St. Tammany Parish Communications District 9-1-1 Dispatch Center
BID NO.: NF-2016-06-16
GLA Project No. 14109

ADDENDUM NO. 3

Date: 03 August 2016

SK 07

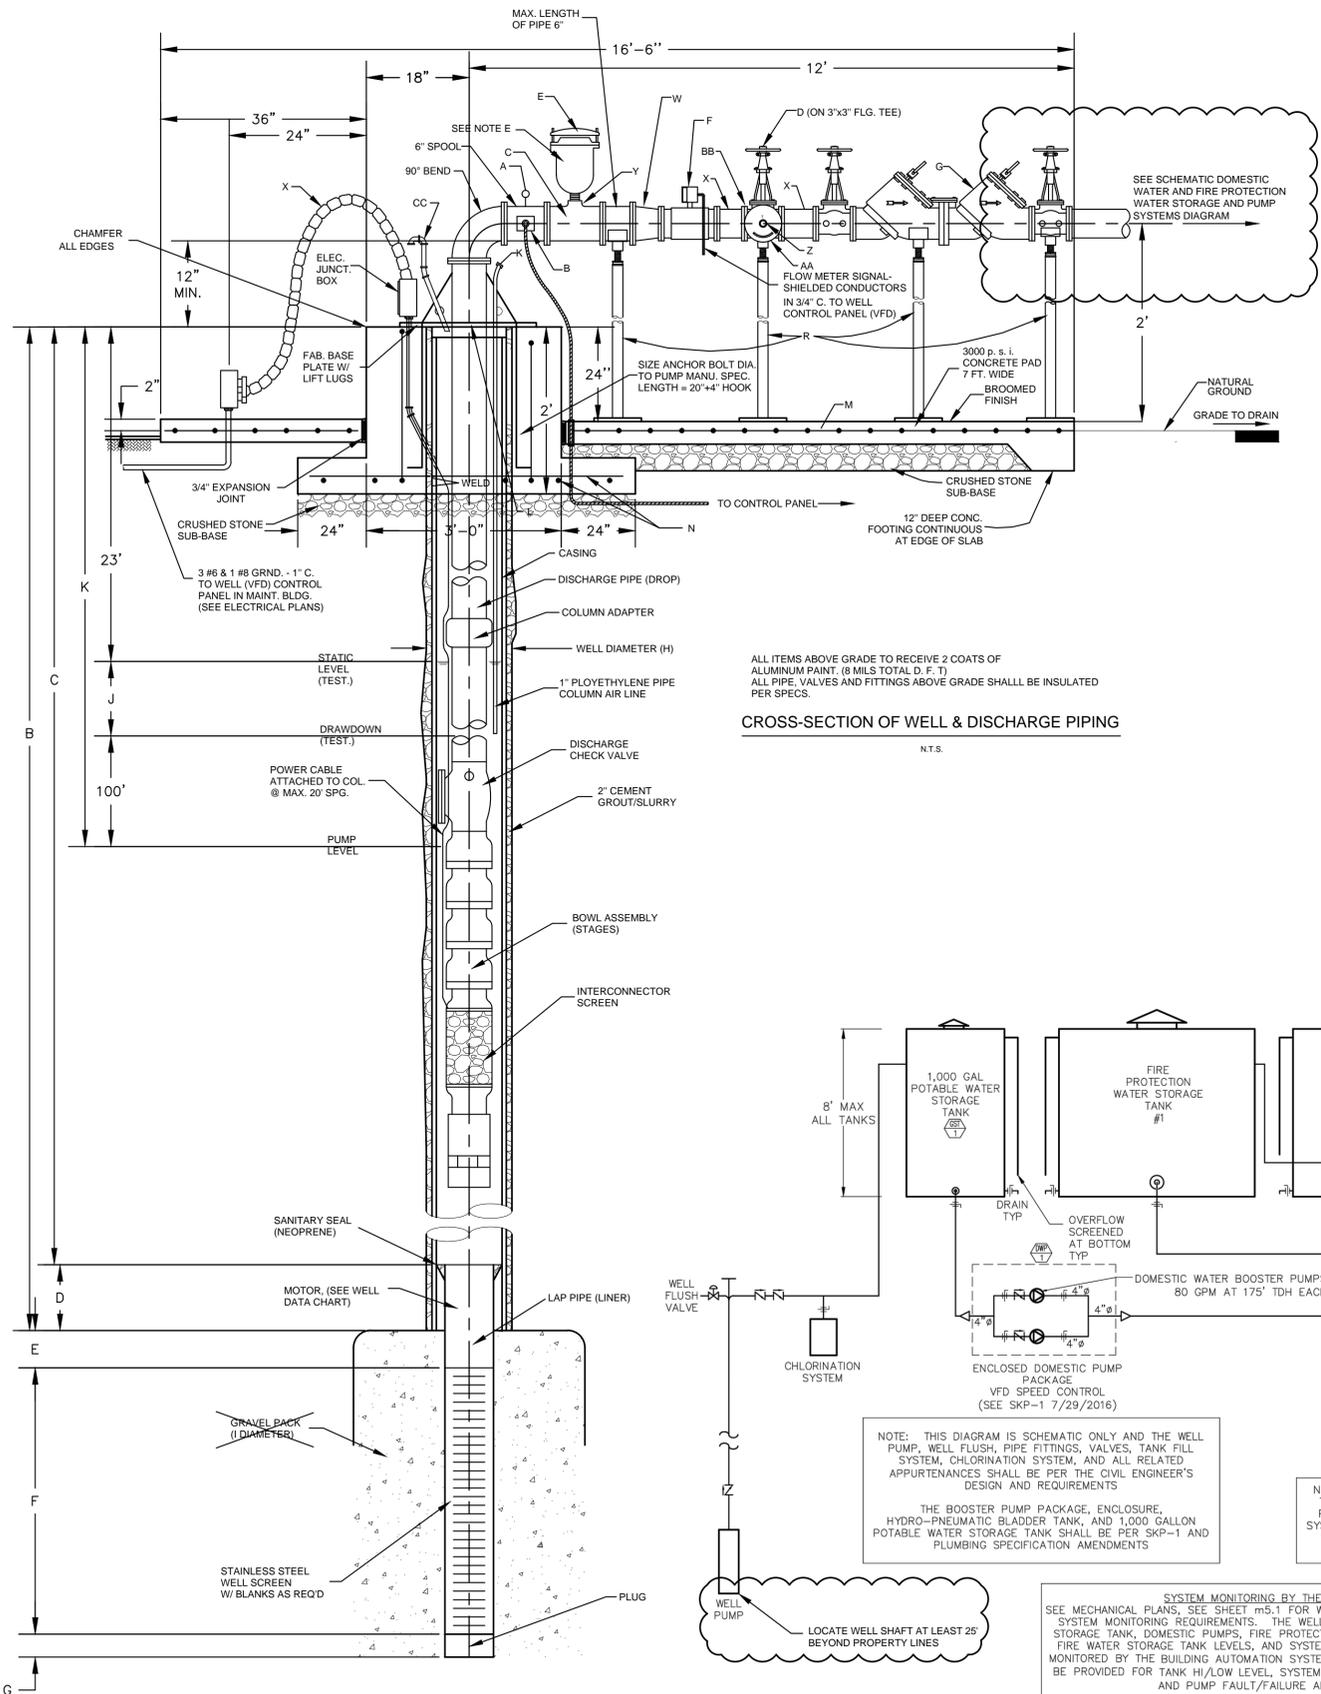
- 2.15 **Sheet a054 Detail 11:** Revise detail as shown on attached sketch **SK 09**.
- 2.16 **Sheet a300 Roof Plan:** Add second line of expansion joints at standing seam metal roof system as shown on attached sketch **SK 07**.
- 2.17 **Sheet a401 Detail 2:** There is no gutter at the lower edge of the roof fascia.
- 2.18 **Sheet a603 Detail 2:** Wall finish above millwork shall be acoustical panel system. Architectural millwork finish shall be wood veneer.
- 2.19 Replace **Sheet C05** with **Sheet C05R** (attached herein).
- 2.20 Provide domestic water booster pump station and domestic above-ground potable water storage tank in accordance with Sheet **SKP-1** (attached).
- 2.21 Finish Selections issued herein reflect the basis of Design. Owner has approved these finishes. Any submitted products must be equal in quality and meet color/texture, maintenance criteria established.
